1R - 426-99

From: Katie Jones [kjones@riceswd.com]
Sent: Wednesday, February 02, 2011 9:56 AM
To: Hansen, Edward J., EMNRD
Cc: Hack Conder; lpg@texerra.com
Subject: BD O-23 vent (1R426-99) CAP Addendum
Attachments: BD O-23 vent (1R426-99) SB-8 log.pdf; BD O-23 vent LAB 1.13.11.pdf; BD O-23 vent (1R426-99) SB-8 photos.pdf; BD O-23 vent (1R426-99) MW-1R installation photos.pdf; BD O-23 vent (1R426-99) Proposed Liner.jpg; BD O-23 vent (1R426-99) Chloride Mass - Table 1 01.31.11.xls

This email is an Addendum to the BD O-23 vent site (1R426-99) Corrective Action Plan (CAP), submitted to the NMOCD on December 22, 2010. In an email dated January 11, 2011, NMOCD requested ROC determine the extent of the release to the north of SB-2. On January 13, 2011, SB-8 was drilled approximately 15 ft north of SB-2 and MW-1 was replaced with MW-1R, a 4 inch well. MW-1 was plugged on January 21, 2011 using a cement grout with 1-3% bentonite and a 3 ft cap of cement. Based on the findings in SB-8, ROC requests the following as an Addendum to the CAP. SB-8 log, lab results, photos, a new plat showing the proposed liner location, and a new table showing chloride mass calculations are attached. If you ne

Proposed liner

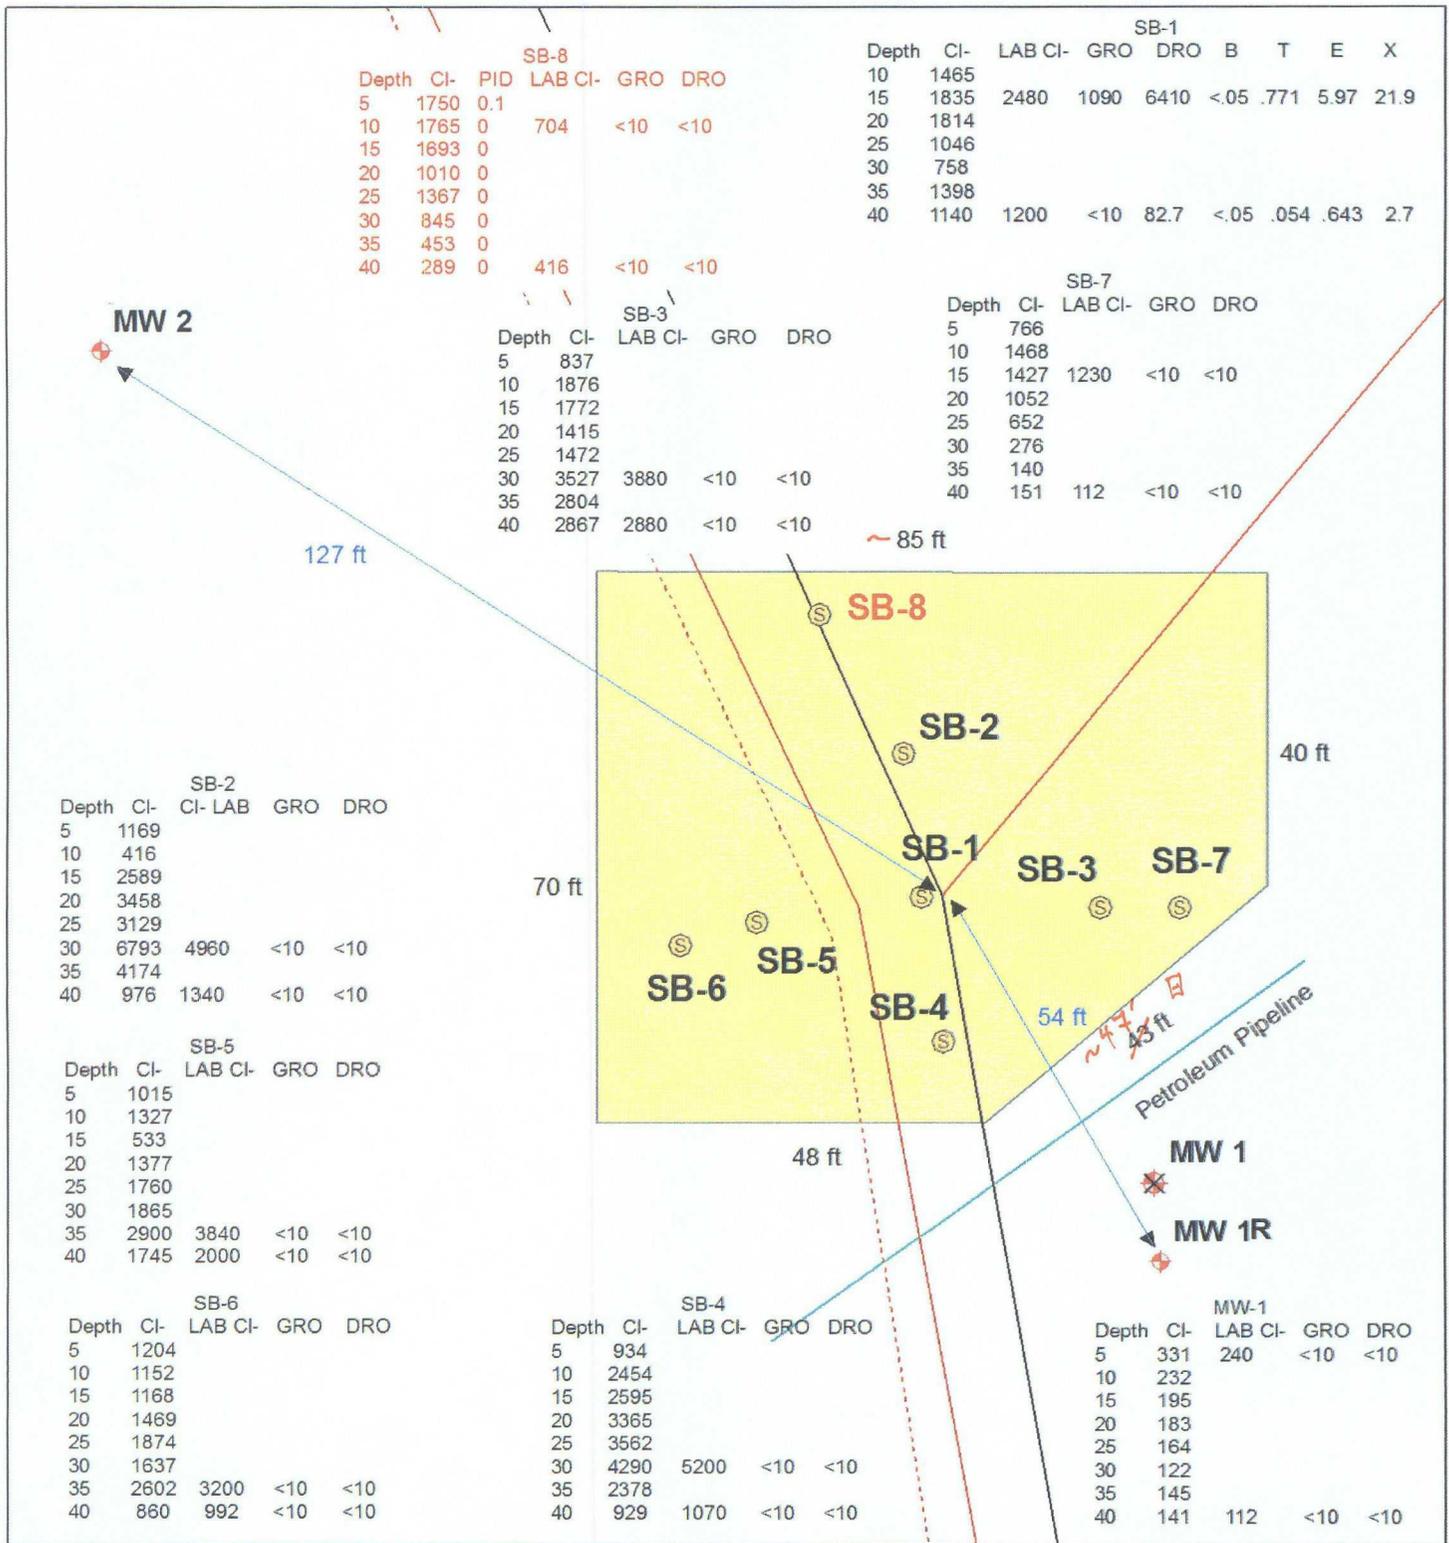
- 1) Remove the upper (approximately) four feet of chloride impacted soils across the area affected by past operations of the BD O-23 junction box (approximately ~~5770~~84 ft with the southeast corner cut off to remain a safe distance away from a petroleum pipeline) and dispose of these in an NMOCD approved facility.

- 2) Install and properly seat a 20-mil plastic infiltration barrier at this depth encompassing the area impacted by the former junction box (as shown in Figure 6), and backfill with clean fill dirt with a chloride concentration below 500 mg/kg and a PID (field) reading below 100 ppm.
